Access Compliance Report

Public Rights-of-Way

(Pedestrian Signals)

Intersection ID: N/A	Main Street:	Cross Street: N/A	Location: N/A
ADA ID: 35C8B994181F	Signal Type: One Push Button-Non APS	Overall Compliance: No	Severity Score: BTN 1: N/A BTN 2: N/A No BTN: N/A
Codes/Mitigation Info/Possible Solution		Field Measurements/Component Compliance

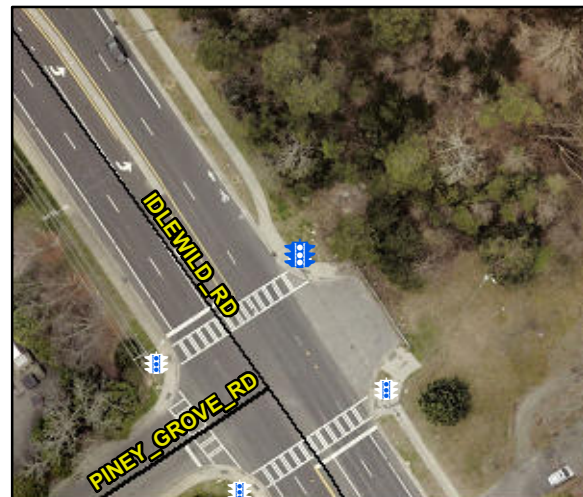
Yes	B 1 Clear Xing Direction?	ClearlyMarked	N/A	B 2 Clear Xing Direction?	N/A
	B 1 Crossing Direction	To SW		B 2 Crossing Direction	N/A
Yes	B 1 DistanceTo XWalk (in)	32.0	N/A	B 2 DistanceTo XWalk (in)	N/A
No	B 1 DistanceTo Curb (in)	94.0	N/A	B 2 DistanceTo Curb (in)	N/A
Yes	B 1 Diameter (in)	2.0	N/A	B 2 Diameter (in)	N/A

Possible Solutions: Replace Signal Push Button With APS Button on New Post. Remove & Relocate Sign.
